**Nuclear Energy Institute  
International Event Scale Meeting  
June 25, 2003**

On January 14, 2002, the Nuclear Regulatory Commission (NRC) issued Regulatory Issue Summary (RIS) 2002-01, "Changes to NRC Participation in the International Nuclear Event Scale (INES)". On July 26, 2002, the Nuclear Energy Institute (NEI) met with the NRC staff in a public meeting in Rockville, Maryland to discuss the INES program changes and provide recommendations for changes in the implementation of the program based on potential unintended consequences.

PWR Typical Technical Specification Activity Example Curve

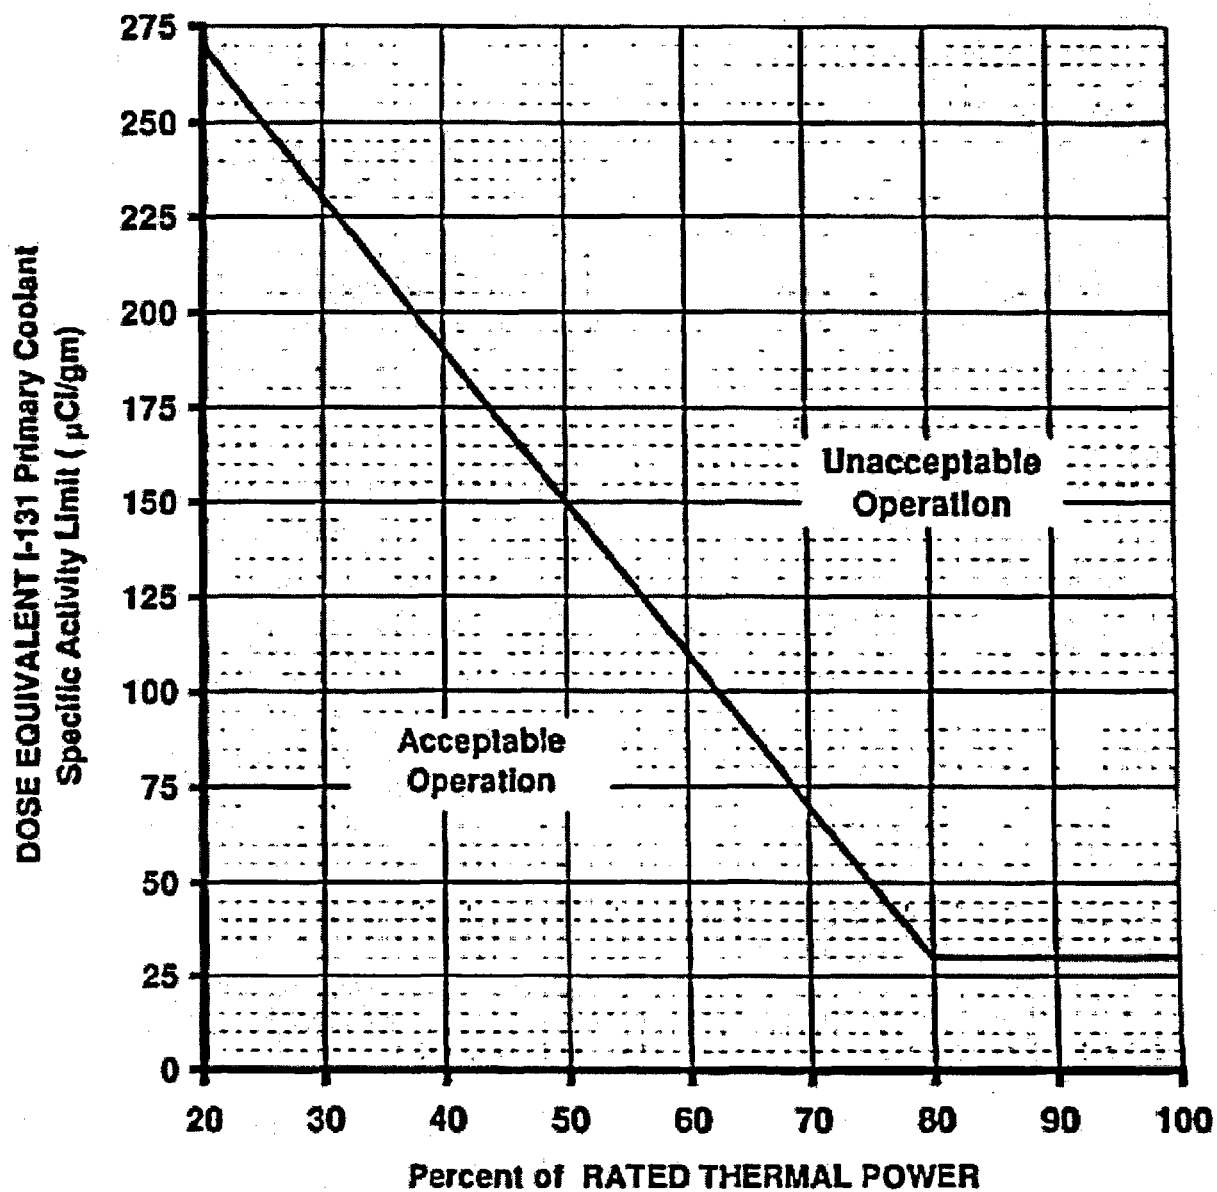
In most US industry events involving fuel clad damage over the last 20 years, RCS activity has remained within the Technical Specification LCO range with I-131 coolant activity remaining in the acceptable operating range of the Technical Specification activity limit curve (an example typical PWR curve is attached). Using a literal interpretation of the INES criteria these events could have been misinterpreted, especially for BWR events, and end up being over-classified using On-Site impact criteria instead of Defense-in-Depth impact criteria. The following supporting details assume that "barrier damage" or "core damage" is synonymous with "clad damage" (i.e., this is not an overheat/melt condition):

DEI elevated into the Unacceptable Operation region of the Technical Specification transient limit requiring shutdown.

DEI elevated into the Allowable Operation region of the Technical Specification transient limit for greater than the specified action statement time limit requiring shutdown.

DEI elevated out of normal Technical Specification operating limit but returned to within normal operating limit within specified action statement time limit with no shutdown required
